Washington Public Power Supply System

Subject: NUCLEAR PROJECT 3
CHANGES TO THE QUALITY ASSURANCE
PROGRAM DESCRIPTION

Attached are the pages to the FSAR QA Program Description showing the additional changes incorporated into Amendment No. 6 (FSAR Change Notices - SCN 351 and SCN 677, Rev. 1).

FIGURE 17.1.4

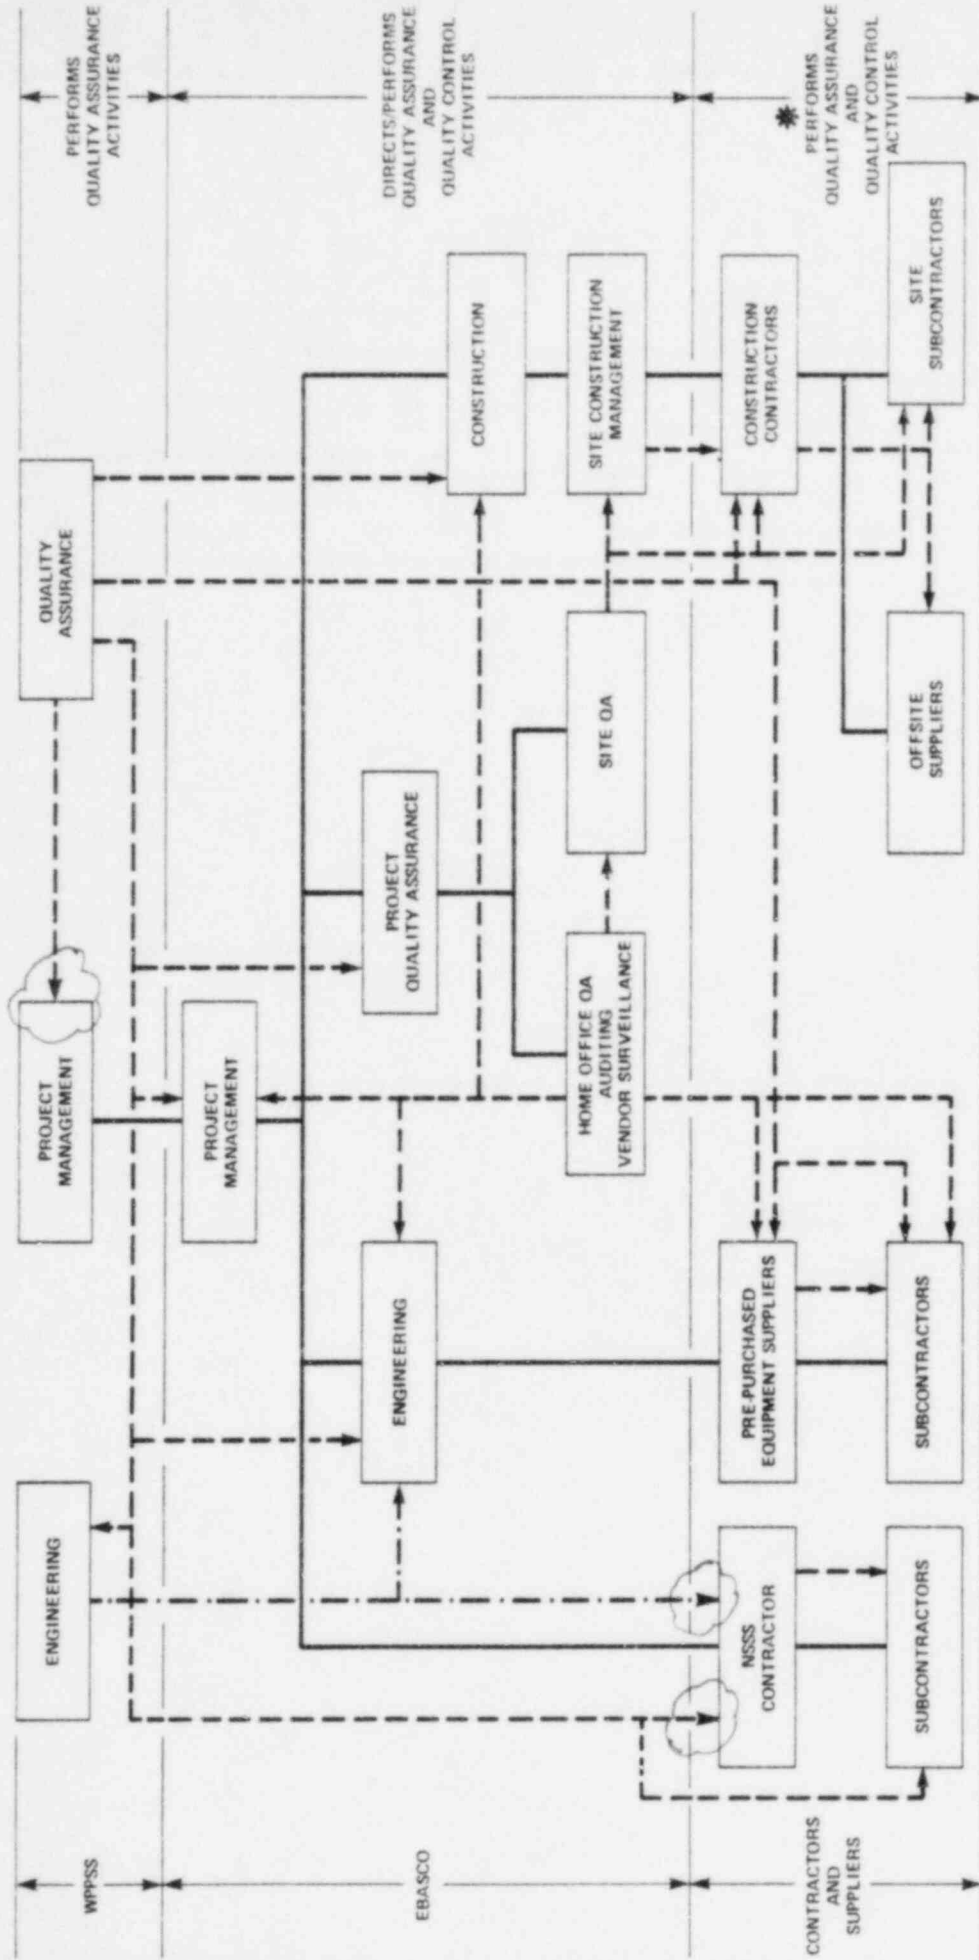
SCN 677, REV. 1

* EBASCO MAY PERFORM THESE QA/QC
 ACTIVITIES IN ACCORDANCE WITH
 PROCUREMENT DOCUMENTS (SEE SECTION
 17.1.1.4).
